Amendments to the Drawings:

REMARKS/ARGUMENTS

In response to the Office Action of December 31, 2003, Applicant requests re-examination and reconsideration of this application for patent pursuant to 35 U.S.C. 132.

Figure 1
Prior art

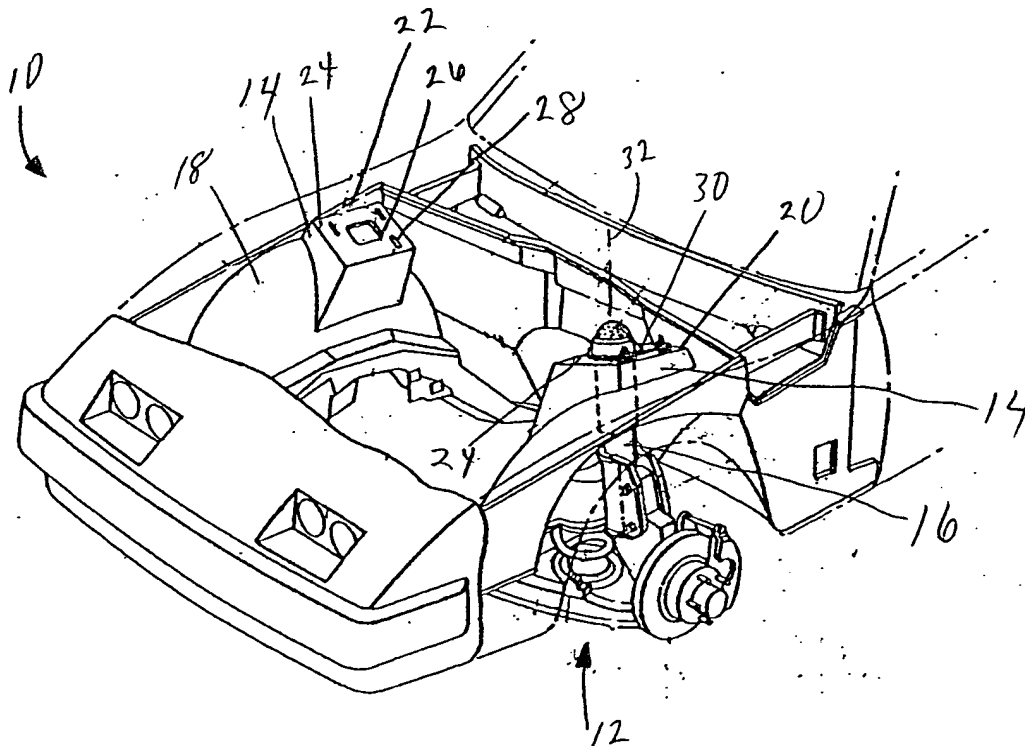
The attached sheets of drawings include changes to Fig. 1. This sheet replaces the original sheet. In Figure 1, previously omitted phrase "prior art" has been added.

In amended Figure 1, the previously omitted phrase "Prior Art" has been added.

Figure 2

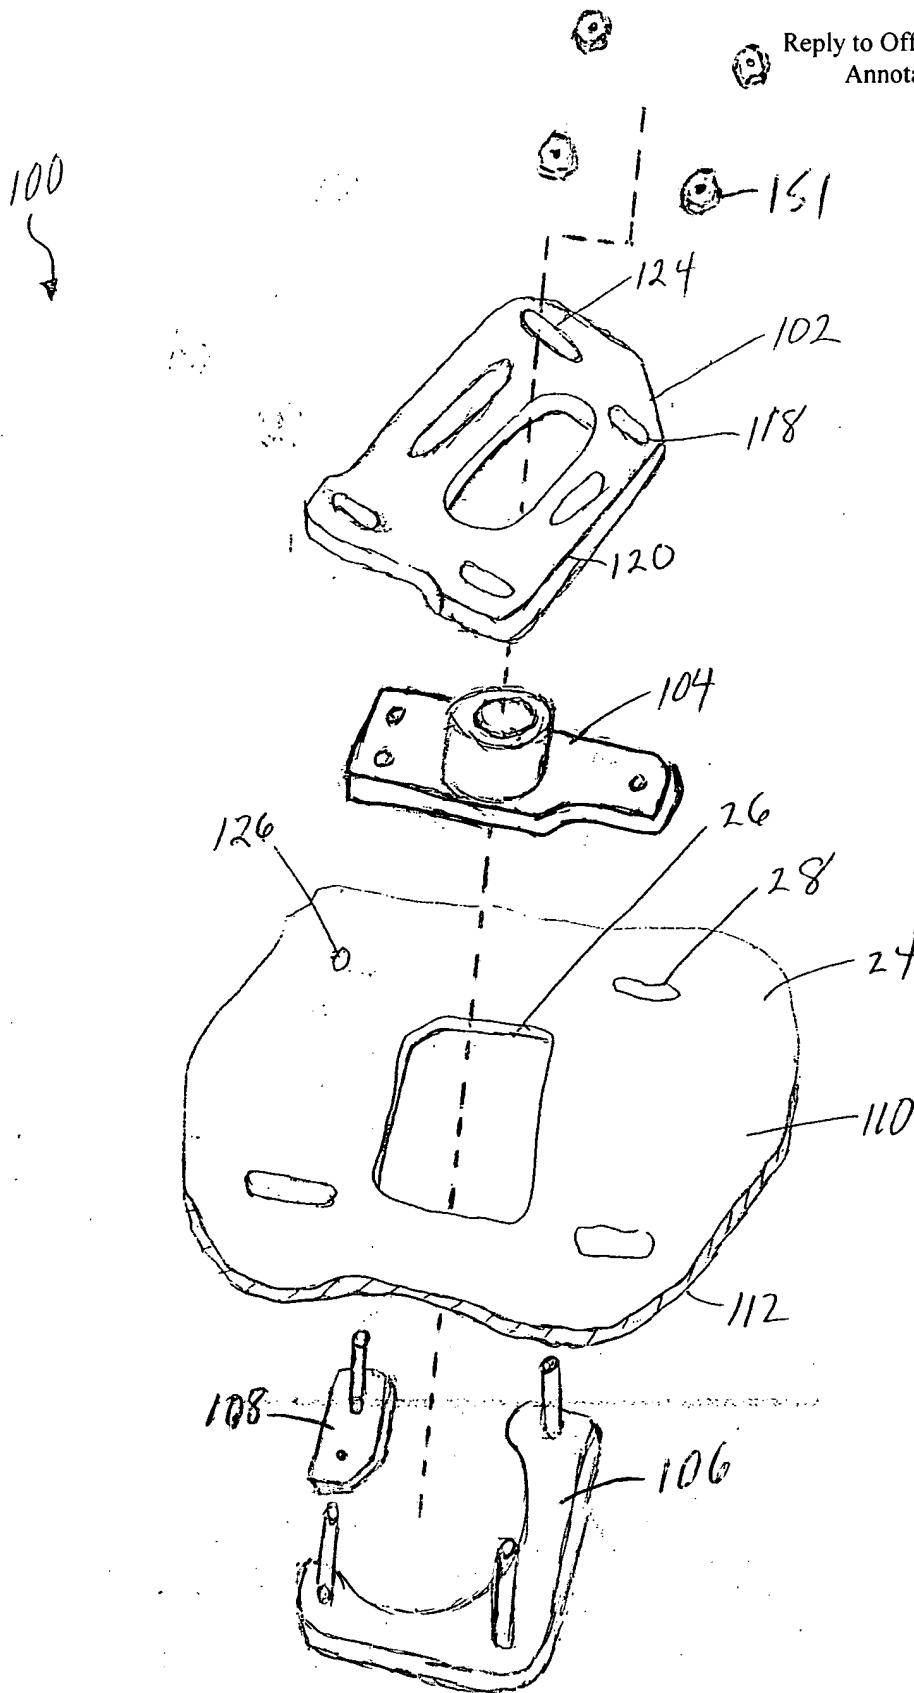
The attached sheets of drawings include changes to Fig. 2. This sheet replaces the original sheet. In this sheet a dashed line illustrating how the parts fit together has been added. This sheet also includes editorial changes to help with clarity regarding assembly of the device.

In amended Figure 2, a dashed line showing how the parts fit together has been added. In addition, Fig. 2 includes illustrative changes to clarify assembly of the device. Fig. 2 also now includes the threaded nuts.

126 in the mounting member of the strut tower and the upper plate 102. A threaded nut (not shown) cooperates with the fourth fastener to secure the upper plate in a selected position with respect to the strut tower." In addition, Fig. 2 has been amended to more clearly illustrate the assembly of the invention as requested by the Examiner.

Claims 1-17 stand rejected under 35 USC 112, first paragraph, as failing to comply with the enablement requirement. Figure 2 has been amended to more clearly illustrate the assembly of the invention. Specifically, plates 106 and 108 have been rotated to illustrate that the bolt or stud of plate 108 aligns with aperture 126 while the bolts or studs of plate 106 align with the elongated slots 28 of the mounting plate.

Figure 3

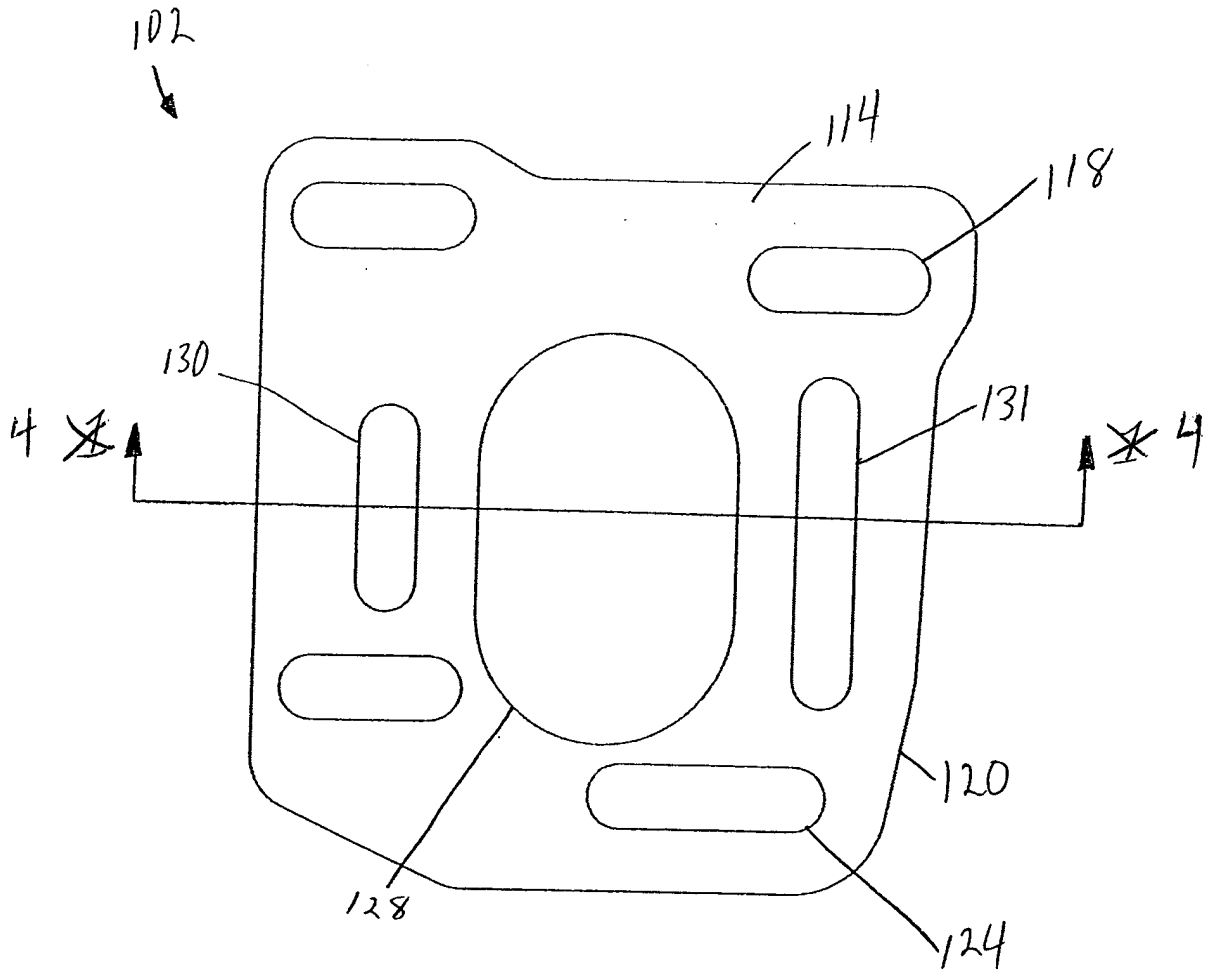
The attached sheets of drawings include changes to Fig. 3. This sheet, which includes Figs. 3 and 4, replaces the original sheet including Fig. 4. In Figure 3, line 1-1 has been amended to line 4-4.

In amended Figure 3, line 1-1 has been amended to line 4-4.

Applicant is uncertain as to the statement regarding a circular aperture in the lower left corner of plate 102 as shown in Fig. 3. Fig. 3 contains all elongated apertures, as shown in Fig. 3. New Fig. 3 is provided herewith to provide clarity.

Figure 4

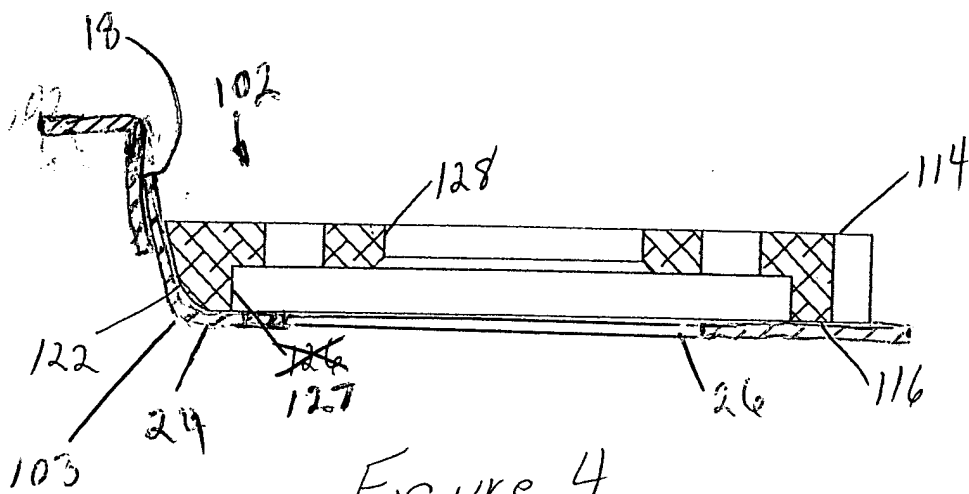
The attached sheets of drawings include changes to Fig. 4. This sheet, which includes Figs. 3 and 4, replaces the original sheet including Figs. 3 and 4. In Figure 4, reference number "126" has been amended "127". Fig. 4 also now includes portions of the inner fender wall 18 and mounting plate 24 to further illustrate the cooperation between the upper plate and the fender wall and fillet 103 as requested by the Examiner.

In the specification, page 20 line 3, the numerical designator 103 has been added. The designator refers to amended Fig. 4 which illustrated the fillet is a segment of a radius. Fillets are commonly formed during the bending of sheet metal components as it is difficult to form perfect right angles without fracturing or tearing the sheet metal. In addition, fillets are used to add strength the finished sheet metal assembly.
